METROPOLITAN AREA PLANNING  
DEPARTMENT

TO: Subdivision Committee  
FROM: Don Losew, Senior Planner  
SUBJECT: Review of Final Plat for Maple Valley Addition (S/D  
90-46)

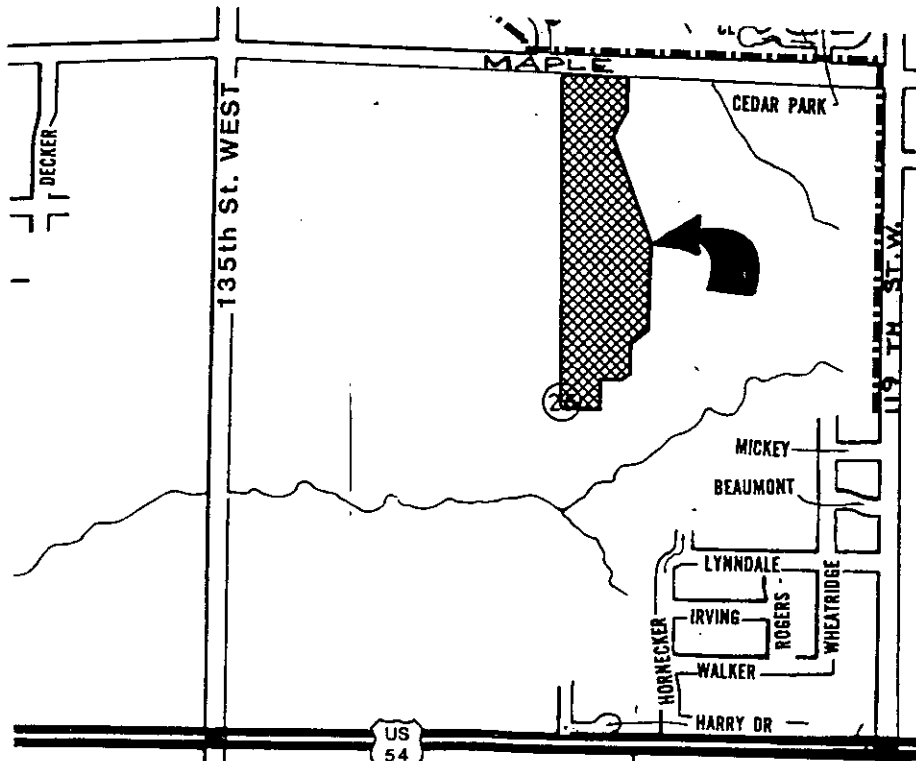
- E. The applicant shall guarantee the paving of the proposed interior streets. The paving petition shall also include the installation of sidewalk on one side of Firefly and Hendryx. In order to provide for the best access to any park development adjacent to this plat it is recommended that this sidewalk be built on the east side of Firefly and south side of Hendryx.

- F. As is required by the Subdivision Regulations, this plat is providing for public access to the planned park, by use of 10-foot walk easements. The applicant shall therefore guarantee that sidewalks are constructed within these easements. If allowed by City Engineering, these improvements may be included in the street paving/sidewalk guarantee already required for this plat. If this improvement cannot be included with that guarantee, a separate guarantee will be needed. This guarantee, however, will have to be other than by petition (cash, letter of credit, bond).

- I. As indicated by the drainage concept for this site, the applicant shall obtain needed off-site drainage easements. These easements shall be submitted to City Engineering for review and approval and to Planning for recording with the plat.

- R. The representative from City Engineering should be prepared to comment on any drainage improvements required for this plat and the acceptability of the minimum pad elevations being platted. Also, at the time of preliminary plat review, this site was required to have undertaken a hydrological study for the entire quarter section in which the plat is located and the applicant was to meet with City Engineering to determine how sanitary sewer service could be provided to the site and if off-site easements were needed. City Engineering needs to indicate if these requirements have been satisfied.

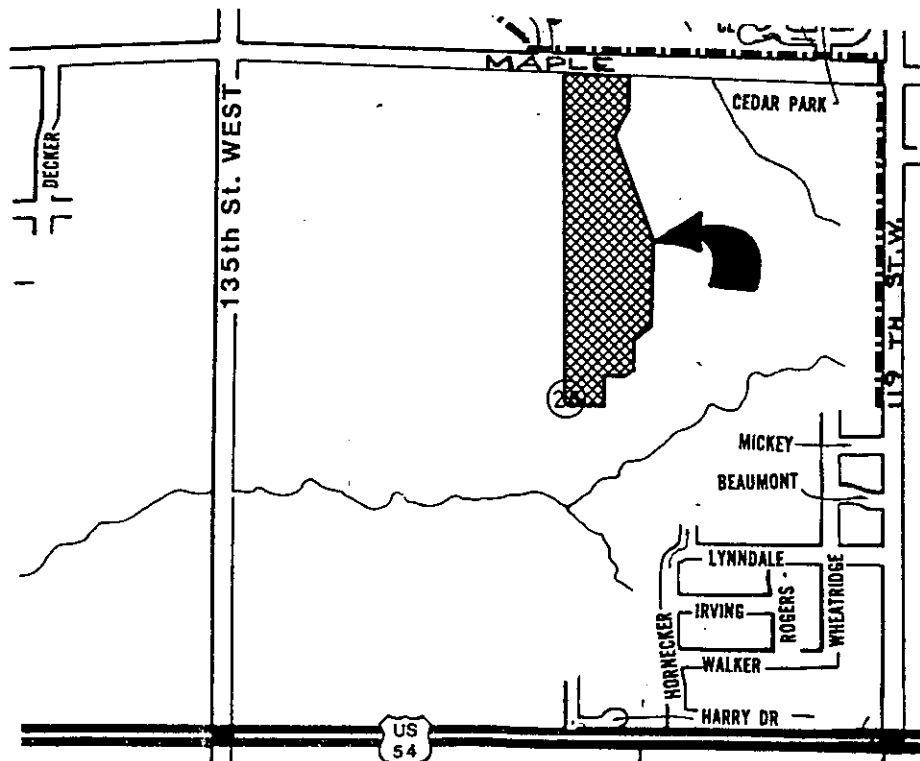
- E. The applicant shall guarantee the paving of the proposed interior streets. The paving petition shall also include the installation of sidewalk on one side of Firefly and Hendryx. In order to provide for the best access to any park development adjacent to this plat it is recommended that this sidewalk be built on the east side of Firefly and south side of Hendryx.

- F. As is required by the Subdivision Regulations, this plat is providing for public access to the planned park, by use of 10-foot walk easements. The applicant shall therefore guarantee that sidewalks are constructed within these easements. If allowed by City Engineering, these improvements may be included in the street paving/sidewalk guarantee already required for this plat. If this improvement cannot be included with that guarantee, a separate guarantee will be needed. This guarantee, however, will have to be other than by petition (cash, letter of credit, bond).

In regard to these walk easements, the plattor's text on the final plat tracing shall also indicate that no fences or other obstructions will be allowed in these easements and that subsequent maintenance of the walks will be the responsibility of adjoining property owners. A restrictive covenant shall also be submitted indicating these restrictions and maintenance responsibilities. This covenant shall specify that it runs with the land and is binding on future owners and assigns. All effected lots shall be specifically indicated in this covenant.

As was discussed during review of the preliminary plat, these easements could be platted as reserves and in turn could be dedicated to the City's Park Department which would maintain any improvements.

- I. As indicated by the drainage concept for this site, the applicant shall obtain needed off-site drainage easements. These easements shall be submitted to City Engineering for review and approval and to Planning for recording with the plat.

- R. The representative from City Engineering should be prepared to comment on any drainage improvements required for this plat and the acceptability of the minimum pad elevations being platted. Also, at the time of preliminary plat review, this site was required to have undertaken a hydrological study for the entire quarter section in which the plat is located and the applicant was to meet with City Engineering to determine how sanitary sewer service could be provided to the site and if off-site easements were needed. City Engineering needs to indicate if these requirements have been satisfied.

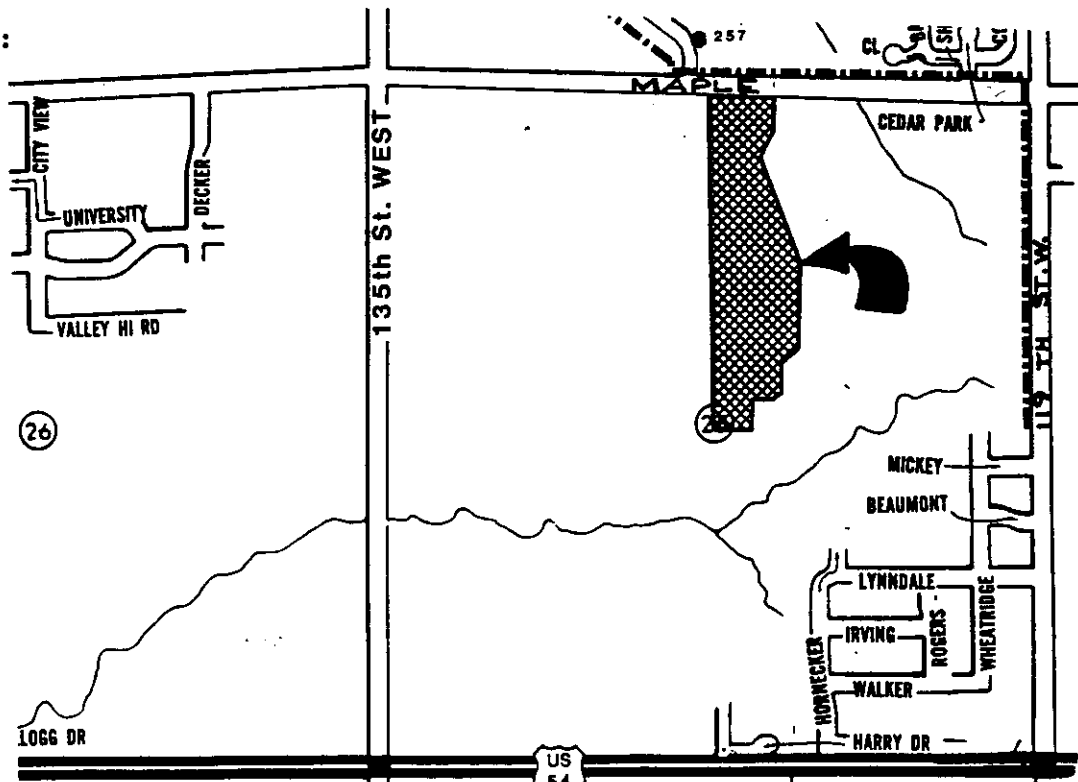
- E. The applicant shall guarantee the paving of the proposed interior streets. The paving petition shall also include the installation of sidewalk on one side of Firefly and Hendryx. In order to provide for the best access to any park development adjacent to this plat it is recommended that this sidewalk be built on the east side of Firefly and south side of Hendryx.

- F. As is required by the Subdivision Regulations, this plat is providing, through use of 10-foot walk easements, for public access to the planned park. The applicant shall therefore guarantee that sidewalks are constructed within these easements. If allowed by City Engineering these improvements may be included in the street paving/sidewalk guarantee already required for this. If this improvement cannot be included with that guarantee a separate guarantee will be needed. This guarantee, however, will have to be other than by petition (cash, letter of credit, bond).

- G. If improvements are guaranteed by petition, a notarized certificate listing the petitions shall be submitted to the Planning Department for recording.
